Amendments to the Drawings

REMARKS

FIGURE 4

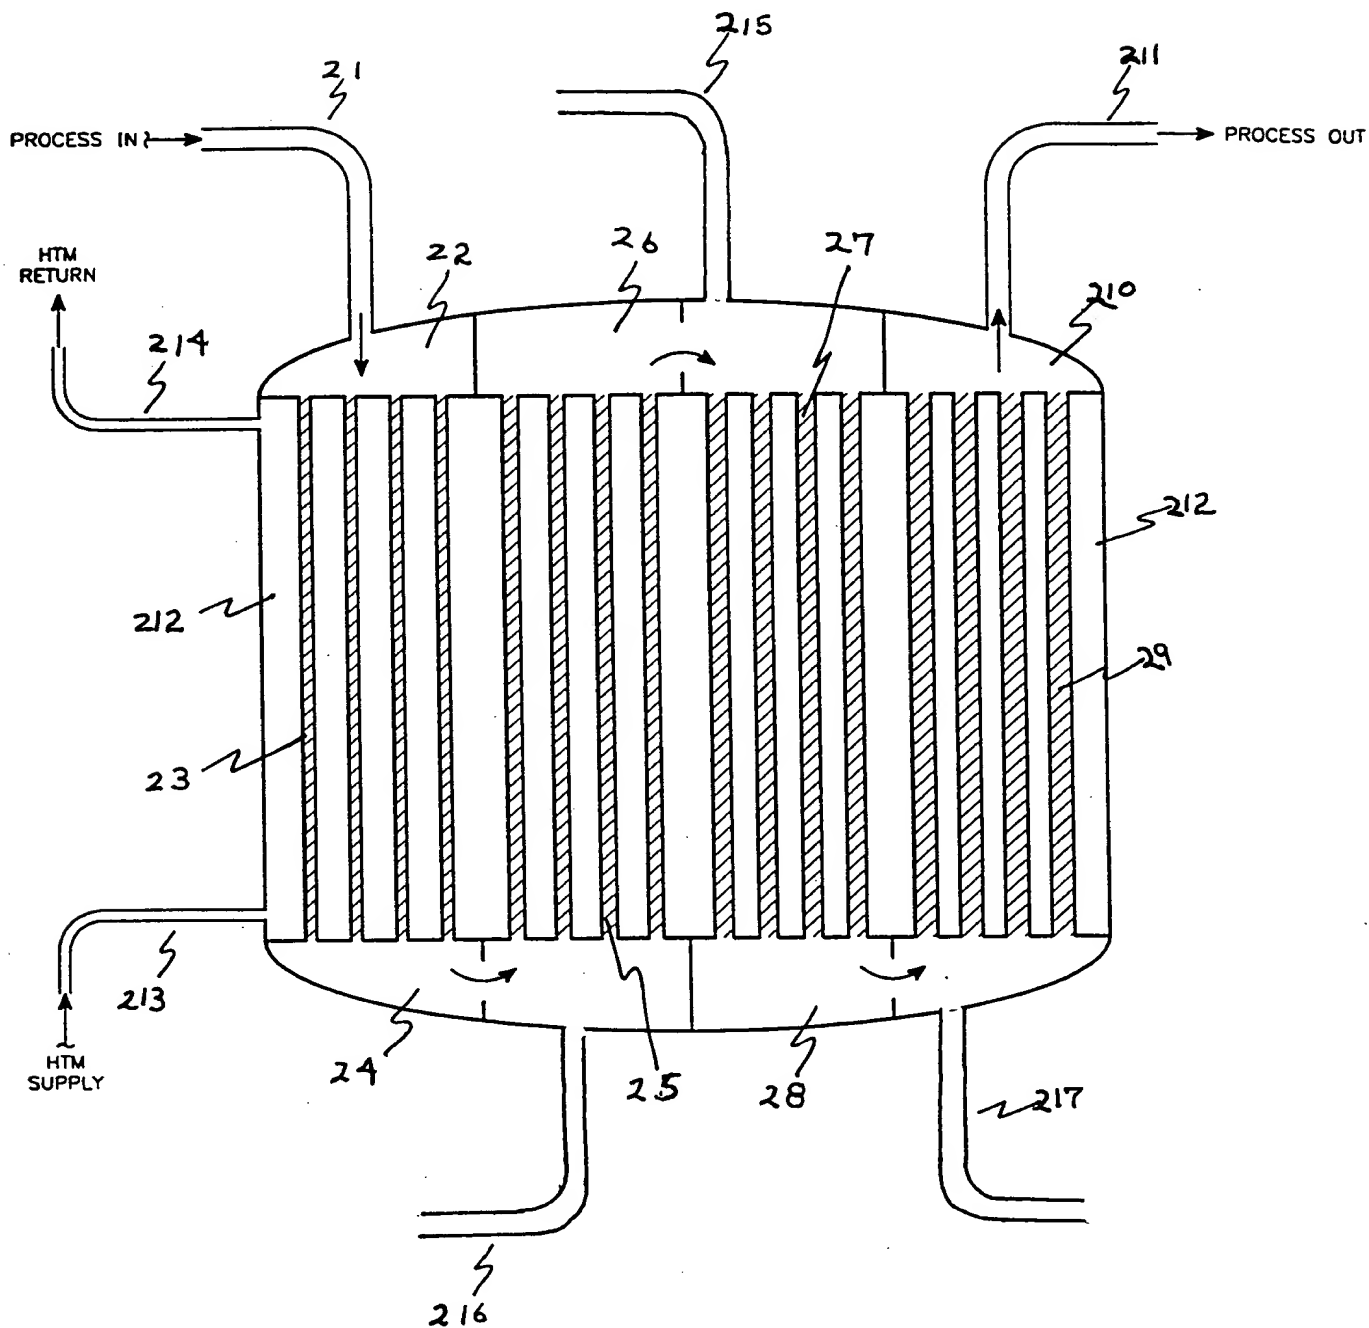
In Figures 4 and 5, the reference character numbers in the drawings have been changed by placing the number "2" prior to each reference character number so that reference character numbers 1, 2, 3, 4, 5, 6, 7, 8, 9, 10, 11, 12, 13, 14, 15, 16, and 17 now read as 21, 22, 23, 24, 25, 26, 27, 28, 29, 210, 211, 212, 213, 214, 215, 216, and 217. This change was made to clarify that the reference characters of Figures 4 and 5 differ from those of Figure 2. Annotated copies of Figures 4 and 5 are included, which show the changes in red.

In the Drawings, Figure 1 has been amended to add the notation "Prior Art" as requested by the Examiner. Figures 4 and 5 have been amended to place the number "2" prior to each reference character number to clarify that the reference characters of Figures 4 and 5 differ from those of Figure 2.
